Access Compliance Report

Public Rights-of-Way

Intersection ID: 12779	Main Street: E_TRADE_ST	Cross Street: S_DAVIDSON_ST	Location: E
ADA ID: 59B124A0E386	Ramp Type: PerpDiag	Initial Pass/Fail: Fail	Overall Compliance: No
		Severity Score: 12.5

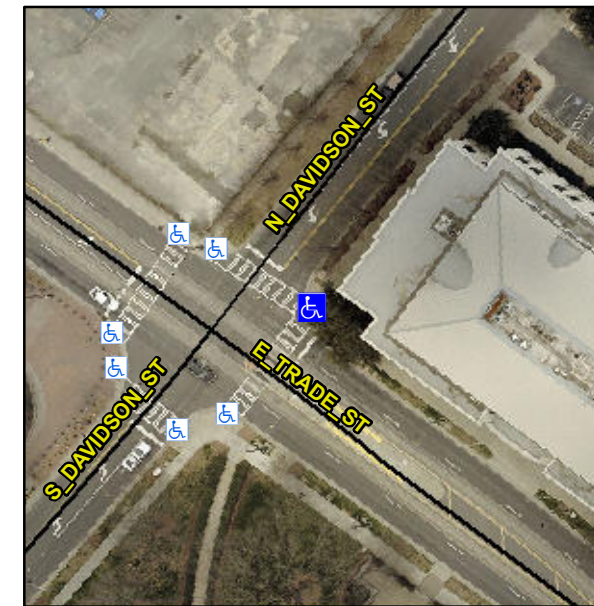
Not Found, R304.5.3

Compliance	Description	Data	Compliance	Description	Data
N/A	Ramp Length (in)	46.0	Yes	Ramp Slope (%)	7.9
Yes	Ramp Width (in)	48.0	No	Ramp XSlope (%)	5.1
N/A	Flare Type LT	N/A	N/A	Flare Type RT	N/A
N/A	Flare Slope LT (%)	N/A	N/A	Flare Slope RT (%)	N/A
N/A	Flare Traversable LT?	N/A	N/A	Flare Traversable RT?	N/A
N/A	Landing Length (in)	N/A	N/A	DWS Provided?	N/A
N/A	Landing Width (in)	N/A	N/A	DWS Contrast?	N/A
N/A	Landing Slope (%)	N/A	N/A	DWS Length (in)	N/A
N/A	Landing X Slope (%)	N/A	N/A	DWS Full Width?	N/A
N/A	Landing Curb? (Y/N)	N/A	N/A	DWS Offset (in)	N/A
N/A	Shared Landing?	N/A			
N/A	Gutter Ponding?	N/A	N/A	Gutter Slope (%)	N/A
N/A	Gutter Lip Ht (in)	N/A	N/A	Gutter X Slope (%)	N/A
N/A	Painted X Walk1?	Yes	N/A	Painted X Walk2?	Yes
	X Walk 1 Direction	To NW		X Walk 2 Direction	To SW
N/A	X Walk 1 Width (in)	113.0	N/A	X Walk 2 Width (in)	112.0
	X Walk 1 Slope (%)	2.5		X Walk 2 Slope (%)	1.7
	X Walk 1 X Slope (%)	2.2		X Walk 2 X Slope (%)	1.6

Remove & Replace Curb Ramp With Two New Directional Ramps or Equivalent.
